Product / Process Change Notification (PCN)	
<input type="checkbox"/> Major change <input checked="" type="checkbox"/> Minor change	
PCN #: PCN_ConFPC_20221226 Affected Series: WE-FPC-6861xx18912x; 6871xx18212x PCN Date: September 26, 2022 Effective Date: December 26, 2022	Change Category: <input type="checkbox"/> Equipment / Location <input checked="" type="checkbox"/> General Data <input type="checkbox"/> Material <input type="checkbox"/> Process <input type="checkbox"/> Product Design <input type="checkbox"/> Shipping / Packaging <input type="checkbox"/> Supplier <input type="checkbox"/> Software
Contact: Product Management Phone: +49 (0) 7942 - 945 5001 Fax: +49 (0) 7942 - 945 5179 E-Mail: pcn.eican@we-online.com	Data Sheet Change: <input checked="" type="checkbox"/> Yes <input type="checkbox"/> No Attachment: <input type="checkbox"/> Yes <input checked="" type="checkbox"/> No
Description and purpose of change: Because of a database mismatch, Würth Elektronik will correct the datasheets. This is a datasheet correction only. There will be no change in form, fit, function, quality or reliability of the product.

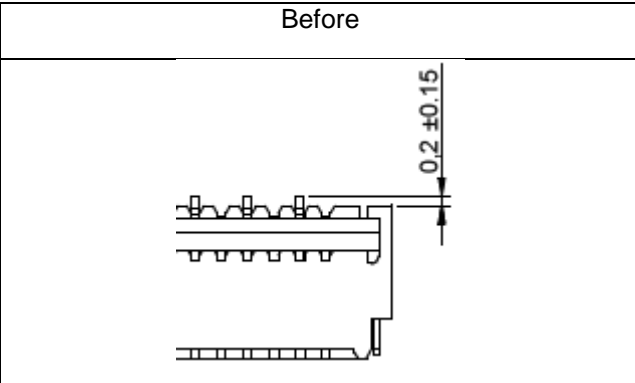
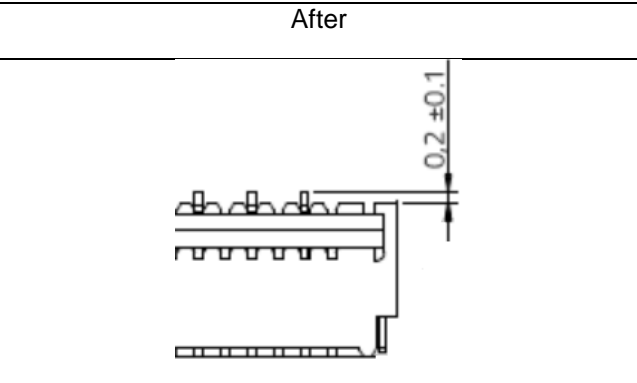
Detail of Change: The pin length will be changed from 0.20mm±0.15mm to 0.20mm ±0.10mm.	
Before 	After 
Reliability / Qualification Summary: There will be no change of the product, therefore no additional reliability or qualification testing will be performed.
